RE: ATRISCO PLAZA SHOPPING CENTER
MHC CENTRAL & ATRISCO
ALBUQUERQUE, NEW MEXICO

PROJECT TITLE RANCH MARKET CORNER OF CENTRAL N.W. & ATRISCO DR. NW ALBUQUERQUE, NEW MEXICO	JOB NO. 0634	DRAWN BY URS
PROJECT MANAGER William Suttles	SHEET TITLE APPROVED LANDSC. PLAN	DATE 4/20/2007
SCALE AS NOTED	SHEET 1	OF 1

ADMINISTRATIVE AMENDMENT
 FILE # 07441402 Project # 100684V
 Reduce drive aisle width
 In front of Market from
 42'-0" to 36'-0"
 APPROVED BY: [Signature]
 DATE: 9 Nov 07

RANCH MARKET
 CENTRAL AVE NW & IRRIGACI DR NW
 ALBUQUERQUE, NM 87104
 PROJECT NUMBER: 0634A
 SHEET NUMBER: 0634A
 SHEET TITLE: OVERALL SITE PLAN

OVERALL SITE PLAN
 SCALE: 1" = 40'-0"
 1" = 40' 0 40 80
 scale feet

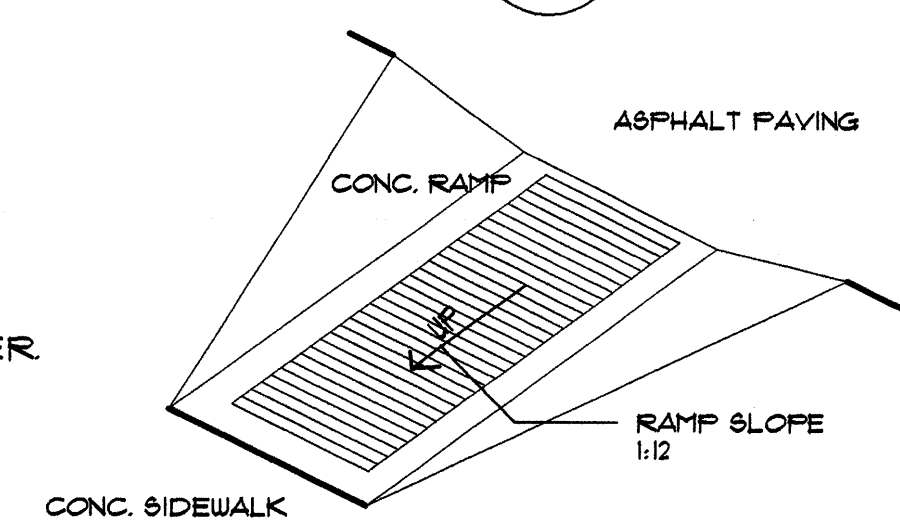
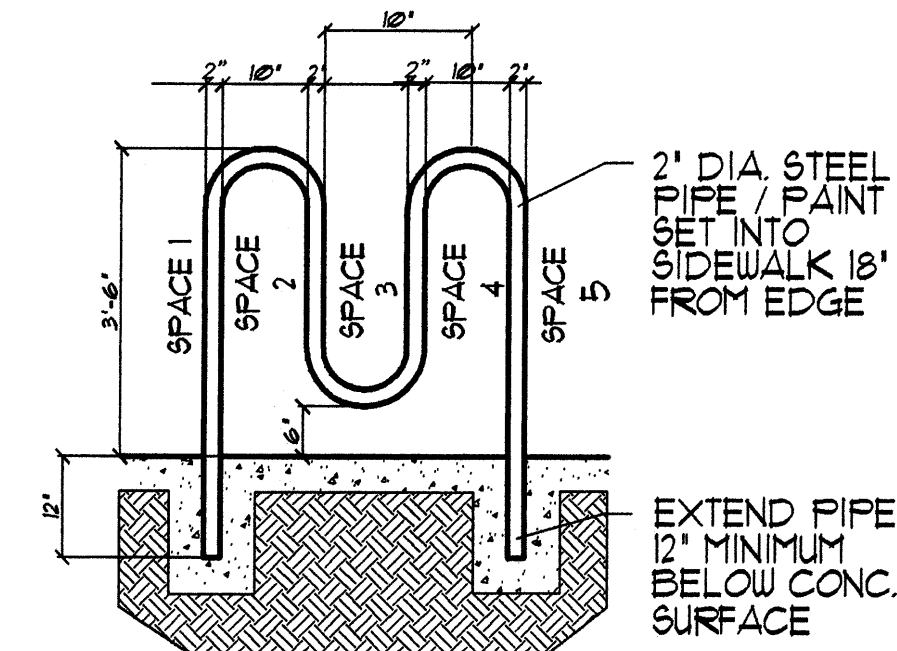
ADMINISTRATIVE AMENDMENT
 FIG. 1006BAY Project # 1006BAY
 Reduce drive aisle width
 in front of Market from
 42' to 35'-0" *9/11/07*
 APPROVED BY *[Signature]* DATE
